BAND ON THE WALL
PROPOSED MEZZANINE FLOOR PLAN
1387 | L 1002 REV. D | JULY '20 | 1:100 @ A3

## PROPOSED MEZZANINE FLOOR PLAN

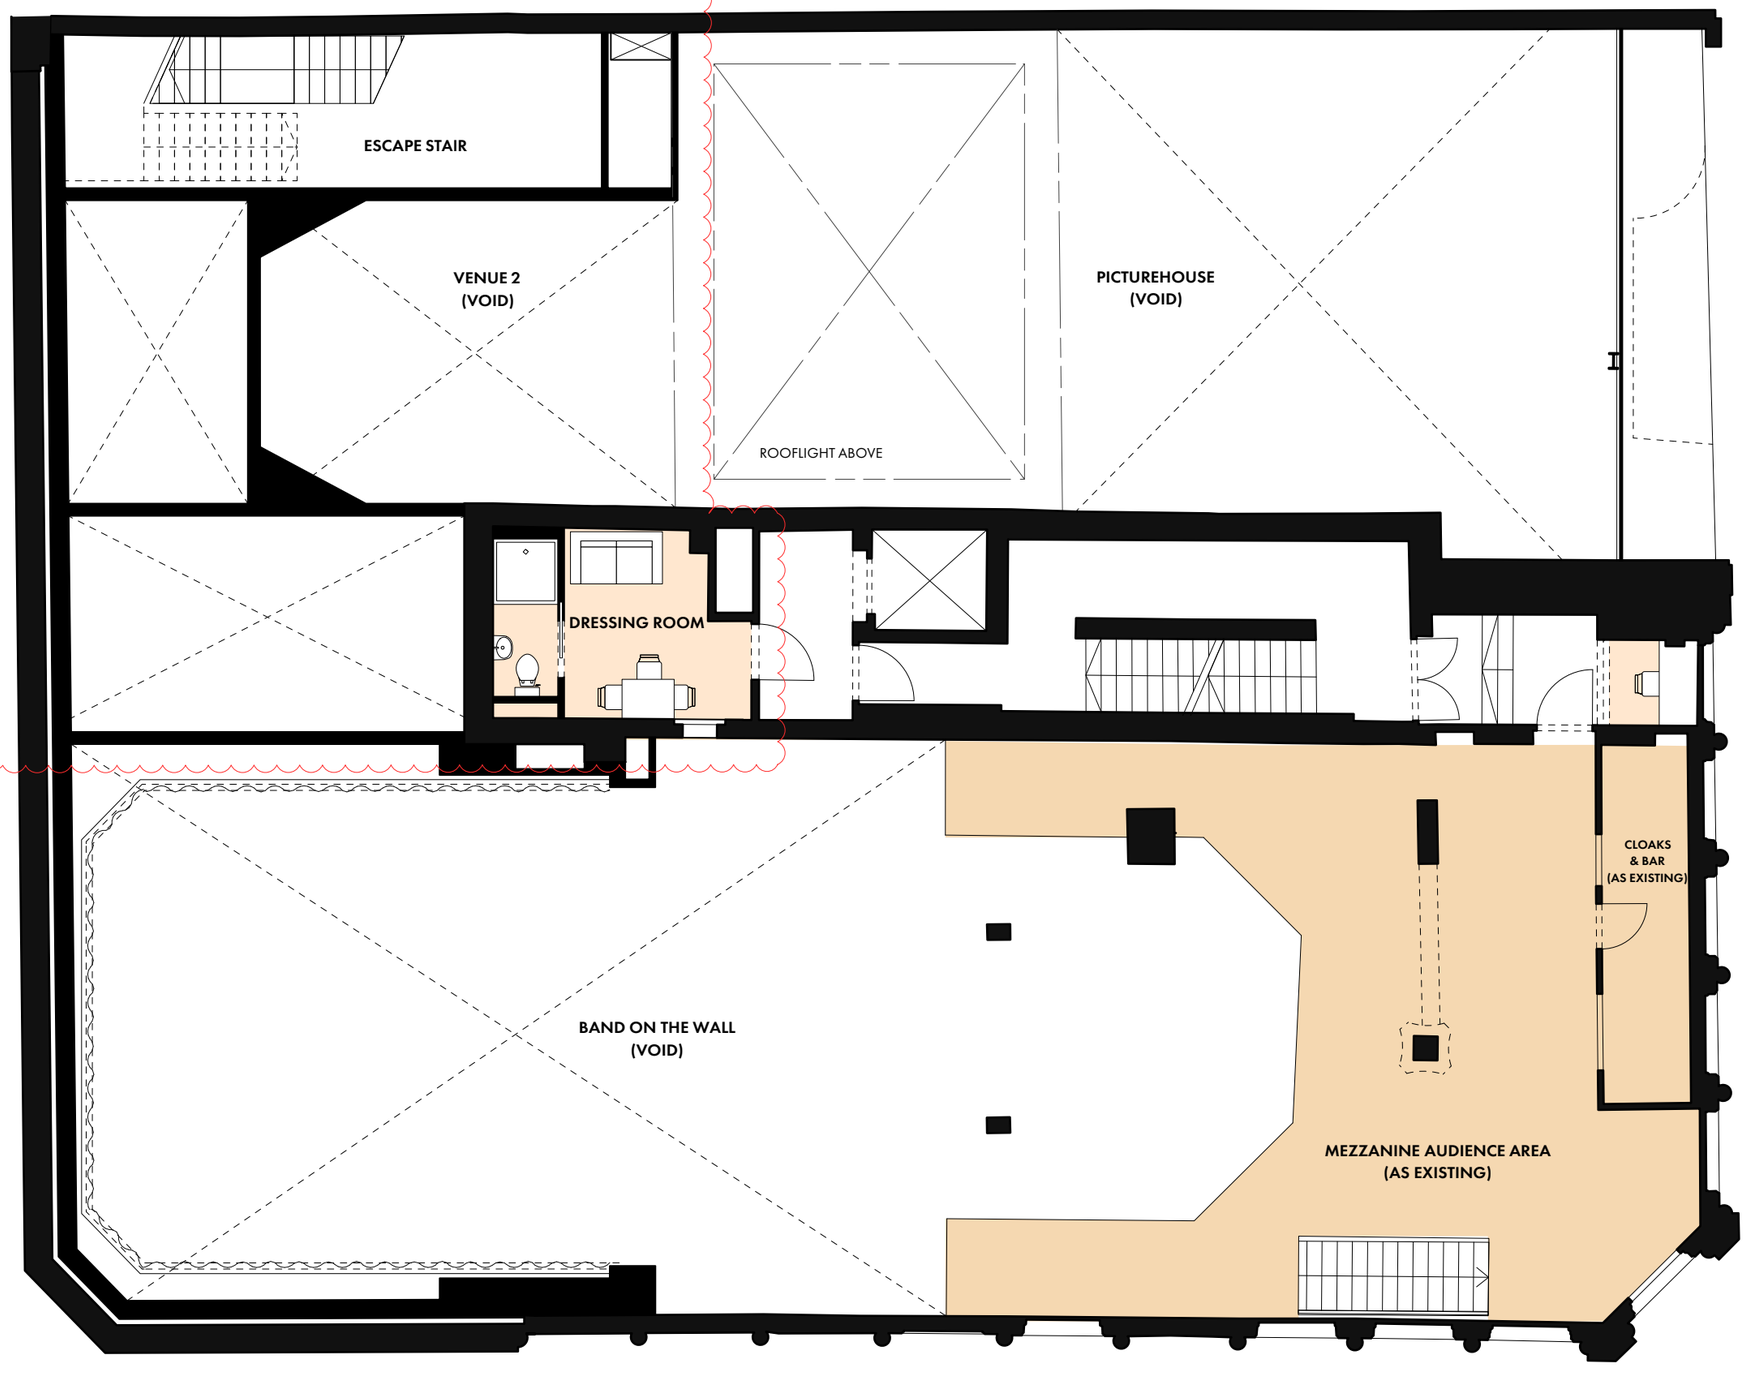
REVISION NOTE:
ACCOMMODATION IN EXTENSION OMITTED AT MEZZANINE LEVEL DUE TO HEAD HEIGHT RESTRICTIONS AT GROUND FLOOR; DRESSING ROOM INSTALLED IN LIEU OF OFFICE; ESCAPE STAIR RATIONALISED TO CHANGES
